CITY OF CODY
PLANNING, ZONING AND ADJUSTMENT BOARD
TUESDAY, APRIL 14, 2015
CITY HALL COUNCIL CHAMBERS @ 12:00 NOON

**CITY OF CODY
PLANNING, ZONING AND ADJUSTMENT BOARD
STAFF REPORT**

MEETING DATE:	APRIL 14, 2015	TYPE OF ACTION NEEDED	
AGENDA ITEM:		P&Z BOARD APPROVAL:	X
SUBJECT:	SITE PLAN REVIEW: MOSS LEASING PROFESSIONAL OFFICE/MEDICAL BUILDING FILES: SPR 2015-12	RECOMMENDATION TO COUNCIL:	
PREPARED BY:	TODD STOWELL, CITY PLANNER	DISCUSSION ONLY:

SHEET:
A-12

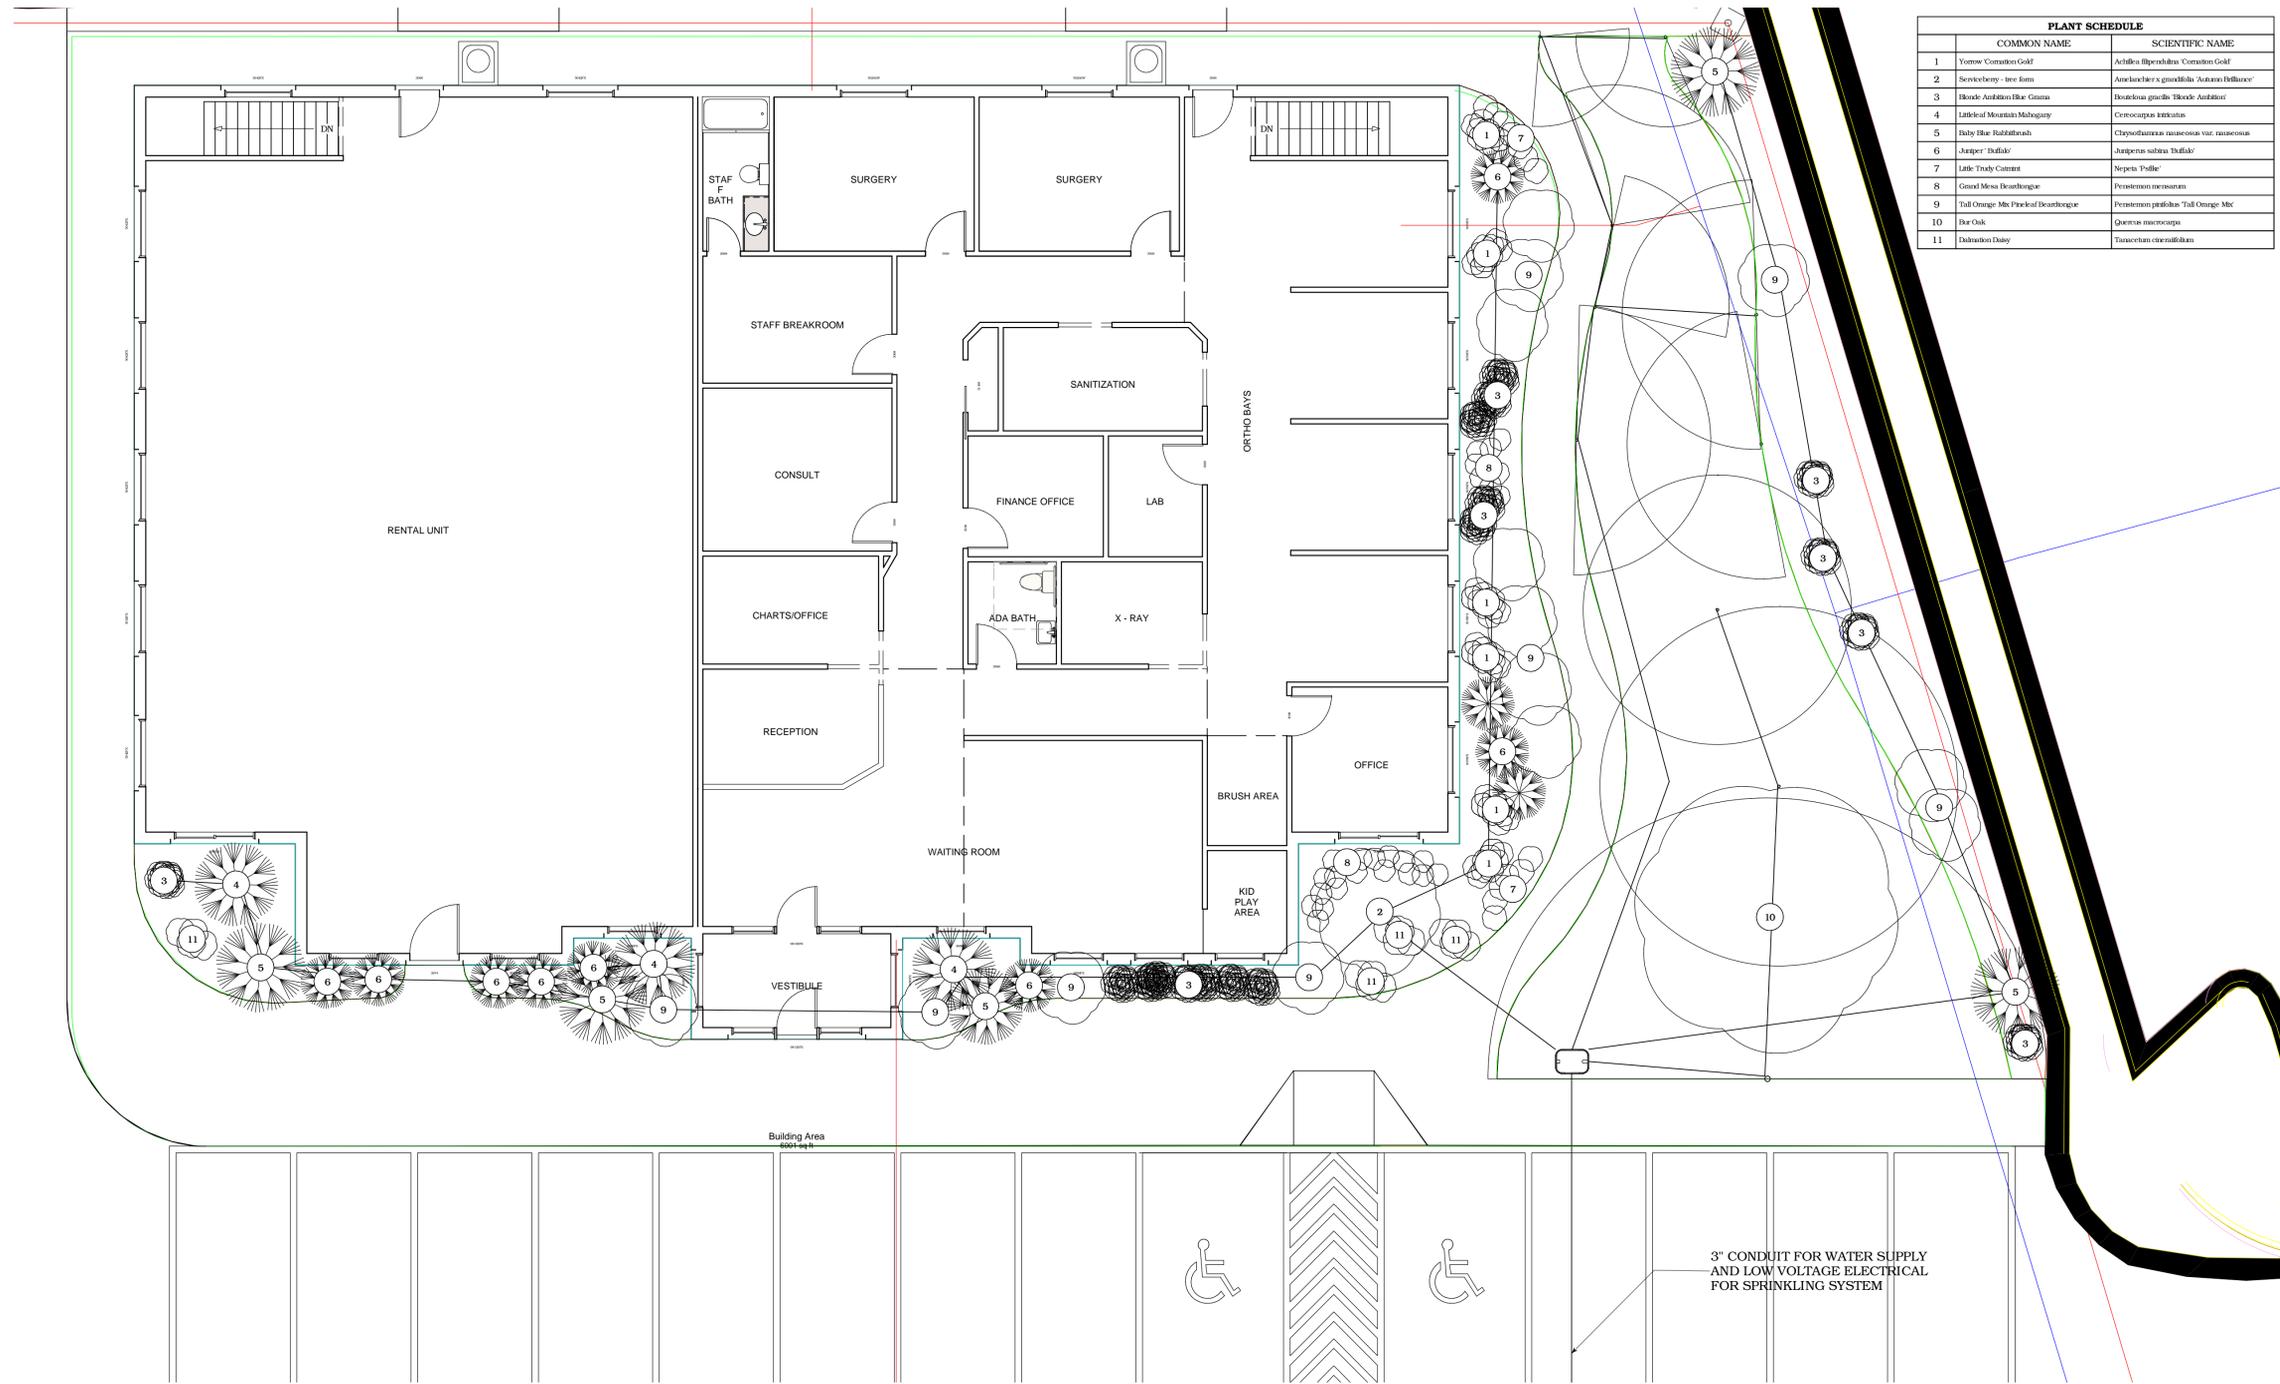
The proposed landscaping around the building is shown on Sheet A-12. It also has been professionally designed and has the desired effect. The one change needed is that the Burr Oak Tree is too large of a tree to meet the requirements for being in a utility easement, and is located too close to the water main. The applicant has indicated that the tree type will be changed and it will be moved further from the water line. If the tree is located within the waterline easement it must be at least five feet from the water line and should be located so that the root system and canopy that does not extend over the water line.

P:\2014\14147_MOSS\record\3D_BASE_CODE\LABS_PROPOSED.dwg C4.0-UTILITY PLAN 4/10/15 (AN

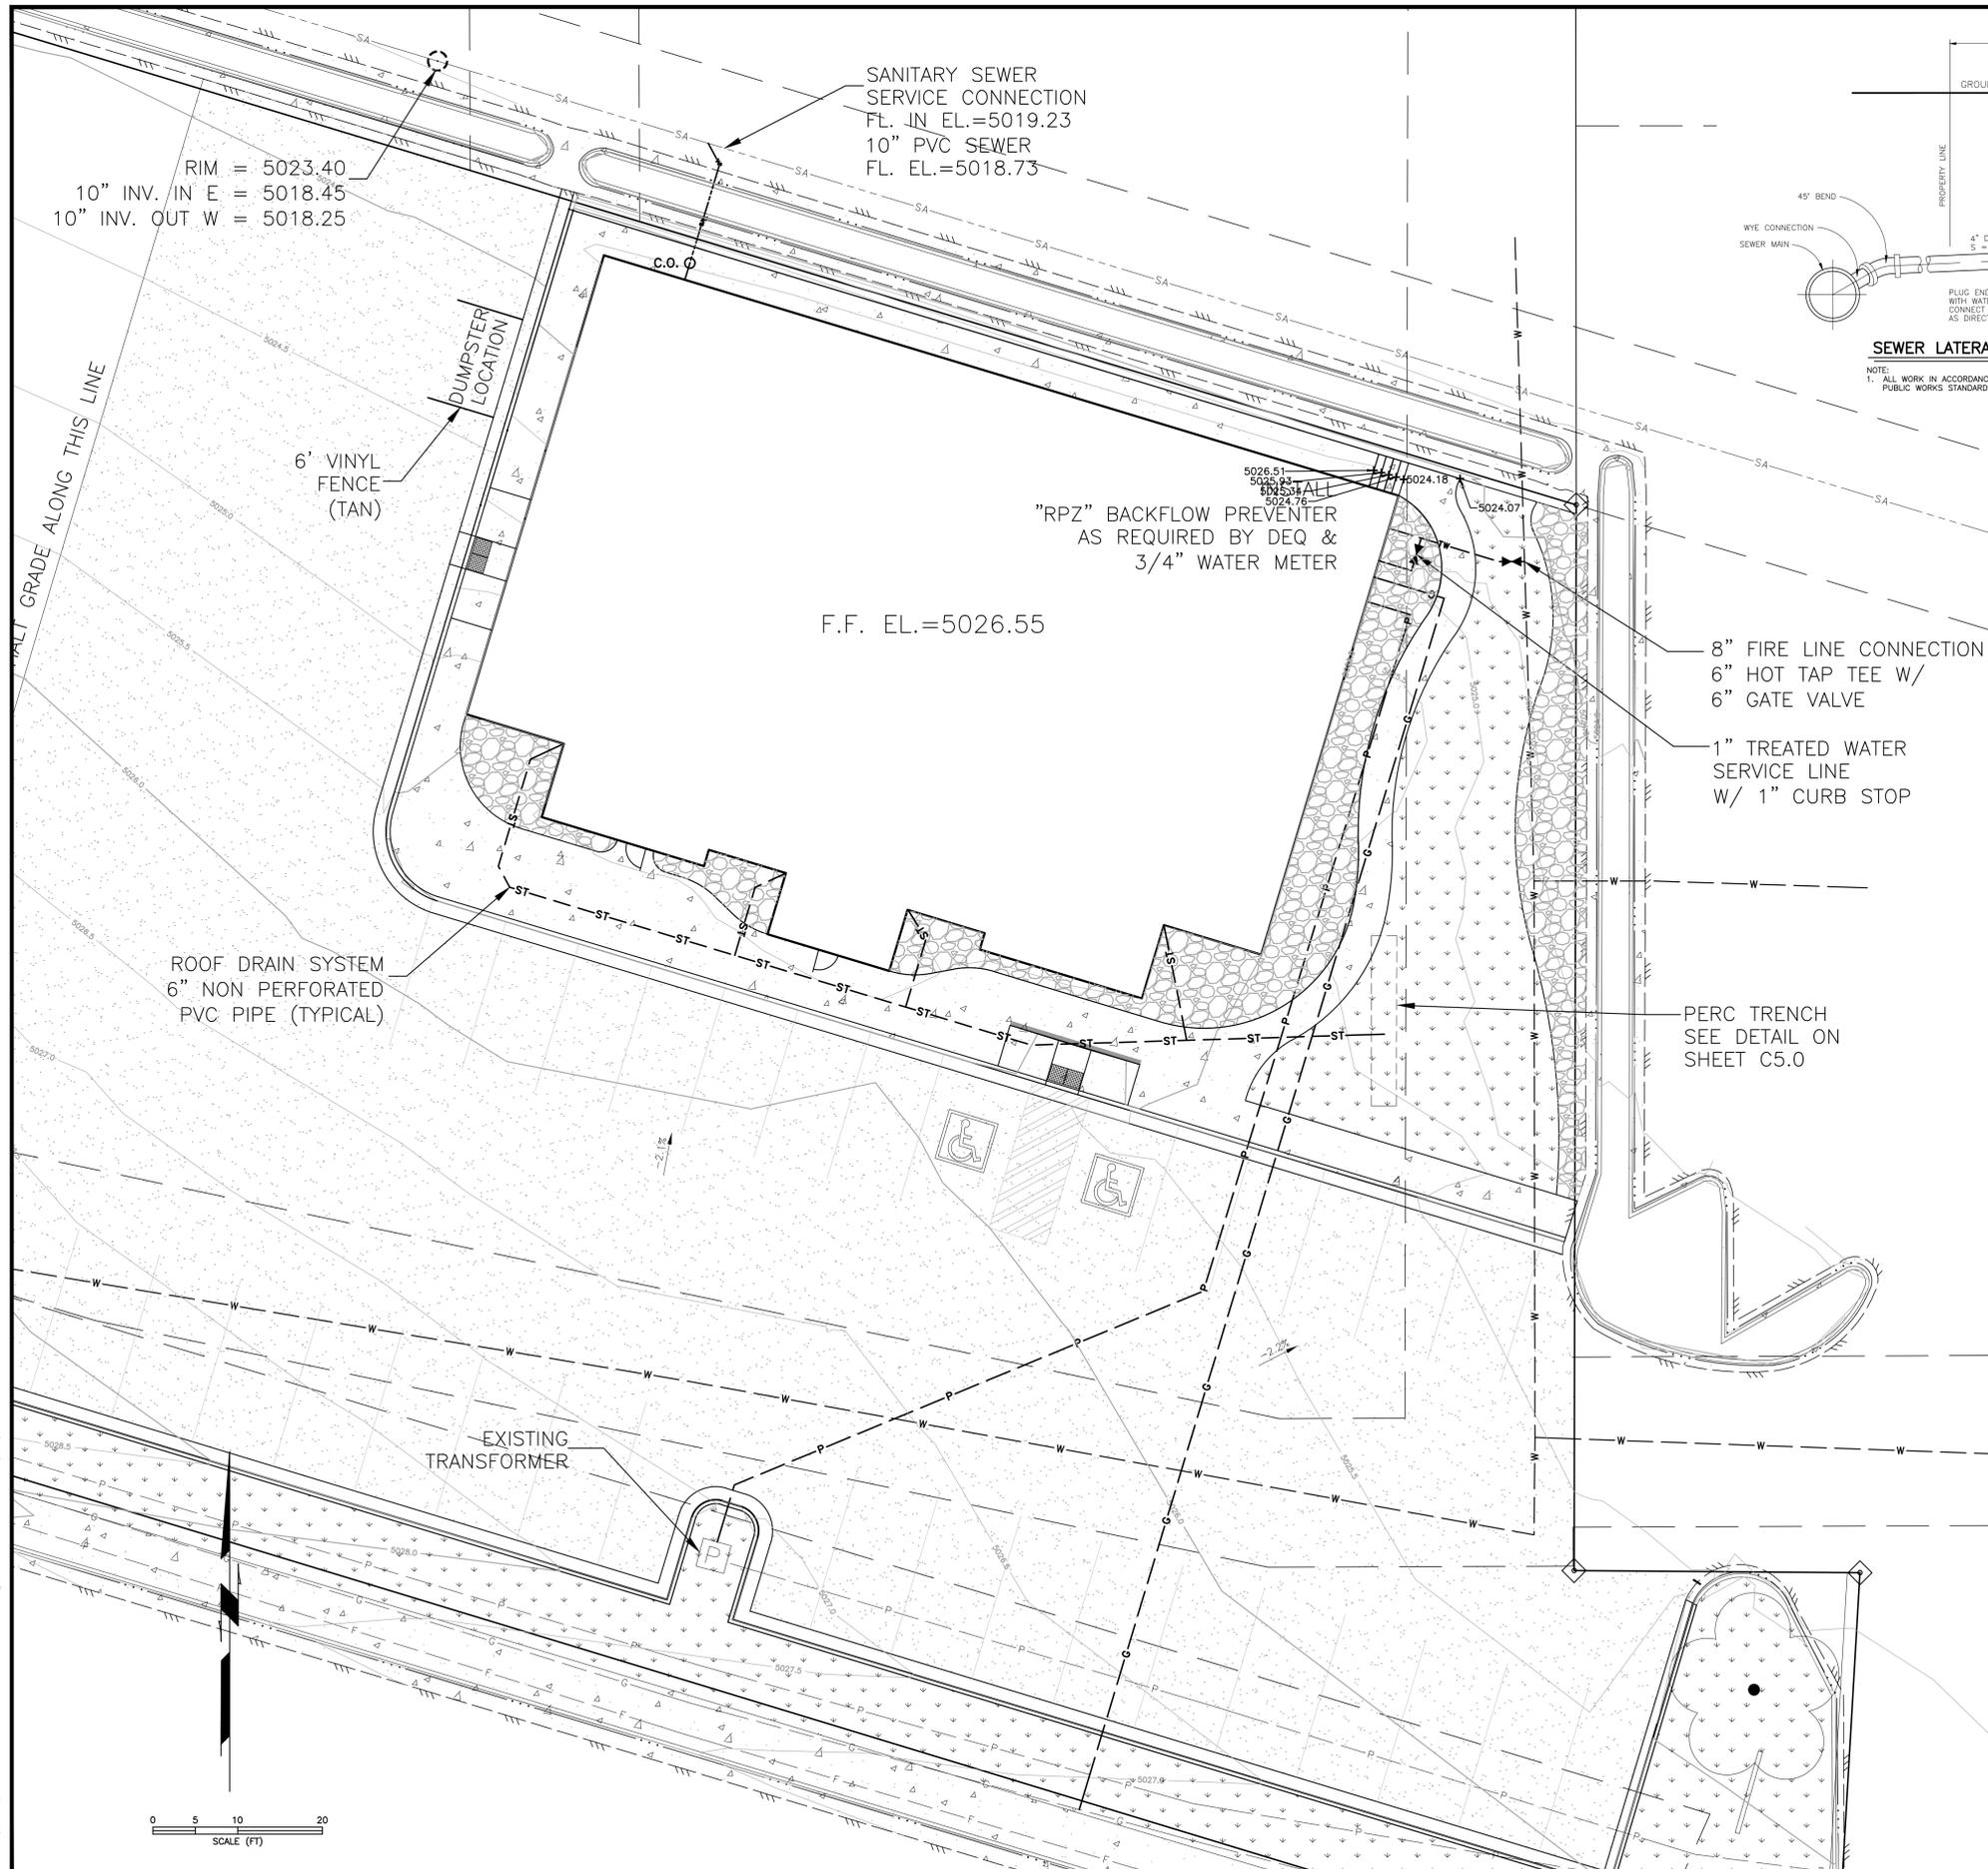
The building will utilize domestic water, power, gas, and sewer service, as shown on the utility plan (Sheet C4.0). Natural gas service and any other private utilities (internet and cable) will need to be coordinated with those providers.

There will be some minor modifications to the water service sizes and meters noted on Sheet C4.0, so that irrigation usage is metered separately. The details will need to be provided no later than the time of building permit submittal. Applicable city utility

1. Provide a detail of the water service line, meters, and RPZ backflow preventer with the building permit application.
2. Pay applicable city utility fees prior to building permit issuance.
3. The Burr oak tree in the landscaping plan is not authorized. A suitable replacement tree and location can be authorized by staff.
4. Obtain a sign permit for any exterior signage. The former Walmart sign must be reduced in height to comply with the 25-foot maximum height requirement. If a building permit is not obtained for the freestanding sign within one year, the former Walmart sign components must be removed in their entirety (including footings) by April 15, 2016.

SHEET:
SD5.1

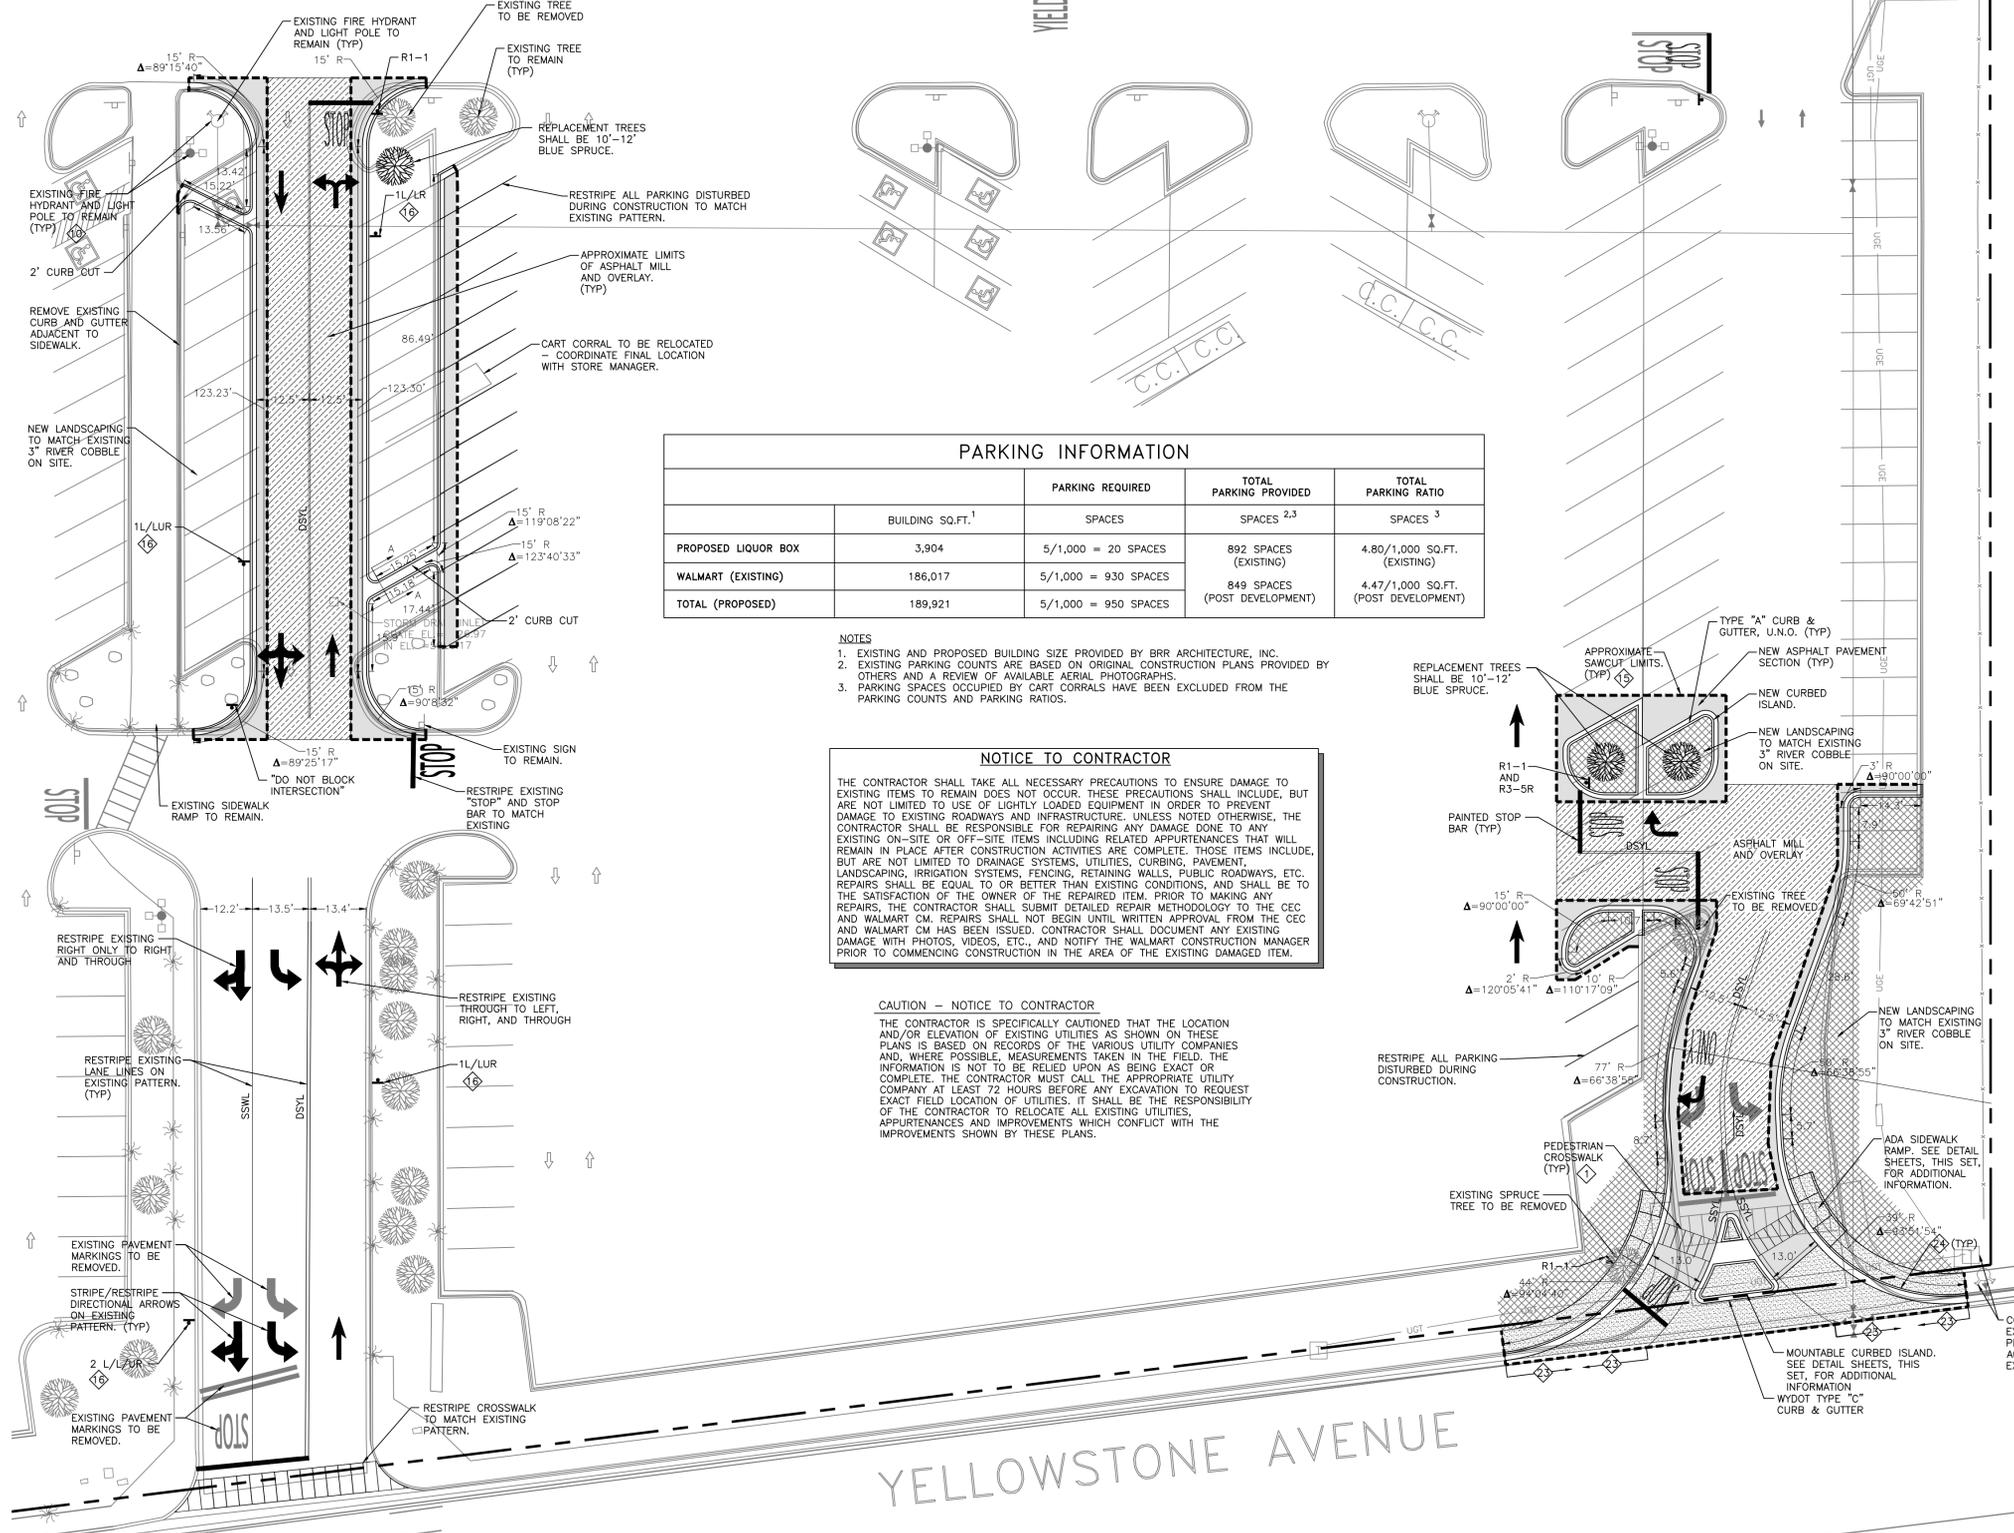
Taking a comprehensive look at the parking lot, the intent is to direct traffic towards exiting the Walmart parking lot at the signalized intersection. To further encourage this, the main drive aisle to the signal will be dedicated for vehicle travel and stacking (waiting)—the parking along the main entrance/exit will be eliminated so that there is no backing into the main drive aisle. Associated work includes lane striping and new islands to formalize an “intersection” where the east entrance meets the main parking lot. Plans are attached. As the work will be done in conjunction with the liquor box addition this spring/summer, the plans have been combined. Sheet SD5.1 shows the overall plan.

Using the standard ratios of the parking ordinance a total of 950 parking spaces would be required for the site. Presently there are 892 parking spaces. With the liquor box addition review, the Board authorized a reduction down to 879 spaces. The proposed parking lot modifications would further reduce the amount of parking to 849 spaces. 849 spaces represents a reduction of 30 spaces from the last approval, and 89.4% of the 950 spaces if the standard ratios were used.

The Planning and Zoning Board may authorize a reduction in the number of spaces required for a use, based on reliable data. In this case, all but the liquor box exists, so there is fairly reliable data as to the anticipated use of the parking lot. As noted with the liquor box review, the 892 space parking lot has been able to accommodate parking for all vehicles even during the peak demand times. Based on recent peak events, the smaller parking lot may reach, or almost reach, capacity for a few hours during the "Black Friday/Thanksgiving" sale, but otherwise it is expected to have plenty of excess parking capacity. Designing a parking lot to accommodate a peak which may occur for only a few hours during the year is not the basis of the ratios used in the parking ordinance, as it is generally considered excessive. Staff is agreeable to the reduction requested.

Approve the Walmart parking lot and entrance/exit modifications, including the resulting reduction in parking spaces, subject to the following:
